Exhibit B
Changes to Draft LUCE as approved by City Council
July 6, 2010

60. Changes to Land Use Map:

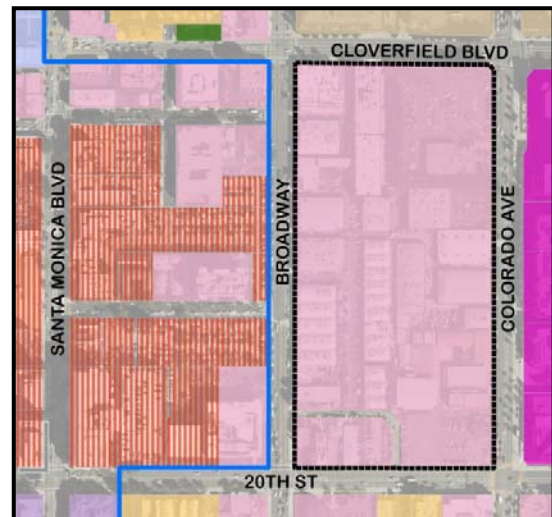
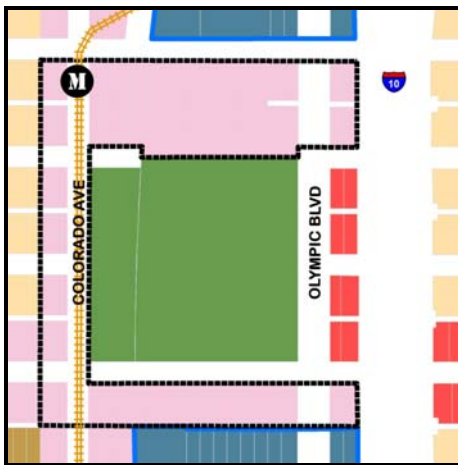
- Change land use designation from Mixed Use Boulevard Low to Healthcare Mixed-Use for properties within St. John’s Health Center South Campus (Chapter 2.1 Land Use Policy)

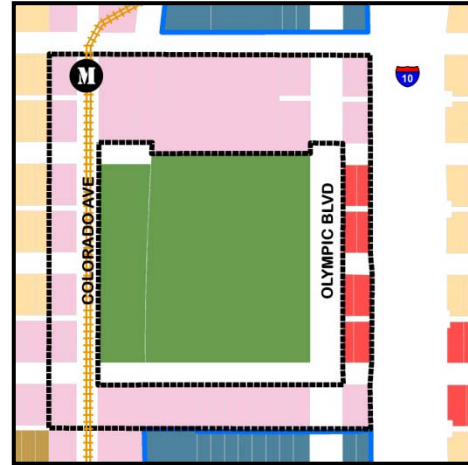
- Change boundaries of Memorial Park Activity Center Overlay to include Neighborhood Commercial parcels on the south side of Olympic Boulevard between 14th and 17th Streets (Chapter 2.1 Land Use Policy)
